SERVICE BULLETIN

Classification: EL07-015	Reference: NTB07-027	Date: May 3, 2007
-----------------------------	-------------------------	----------------------

2007 TITAN AND ARMADA; ENGINE OVERHEATS AND/OR CONDENSER FAN IS INOPERATIVE

APPLIED VEHICLES: 2007 Titan (A60)
2007 Armada (TA60)

Figure 1

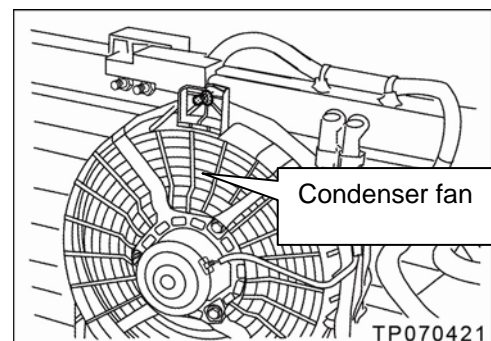
1. Make sure the condenser fan does not already have a jumper harness installed (see Jumper Harness installation on page 3).
 - If a jumper harness is already installed, this bulletin does not apply.
2. Replace the condenser fan.
3. Install a jumper harness onto the condenser fan.

Figure 2

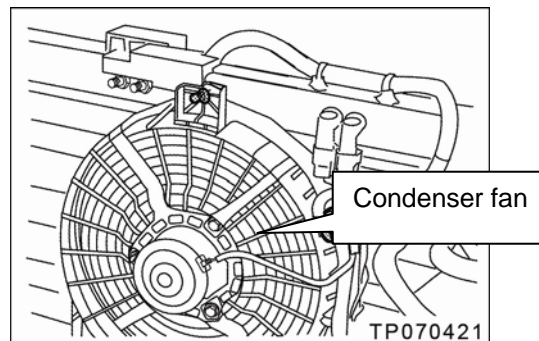
1. Make sure the condenser fan does not already have a jumper harness installed (see Jumper Harness installation on page 3).
 - If a jumper harness is already installed, this bulletin does not apply. Go to ASIST for further diagnostic and repair information.
2. Replace the engine cooling fan—motor driven type (condenser fan).
 - Refer to section CO in the Service Manual for fan replacement information.
 - **During condenser fan replacement, install the jumper harness as shown on the next page.**

Figure 3

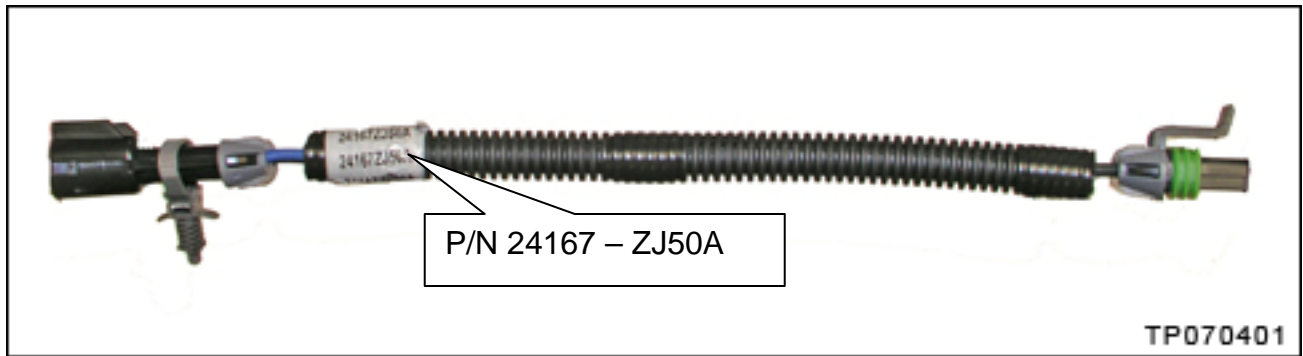
A. Make sure the jumper harness Part Number is 24167 – ZJ50A.

Figure 5

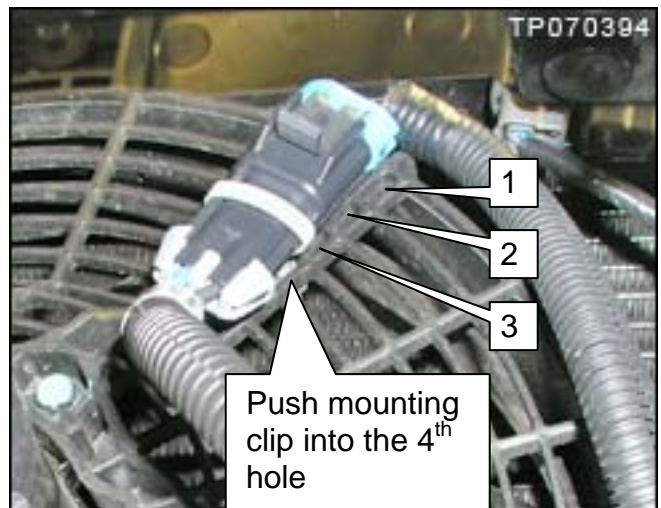
C. Mount the connector in the 4th hole as shown.
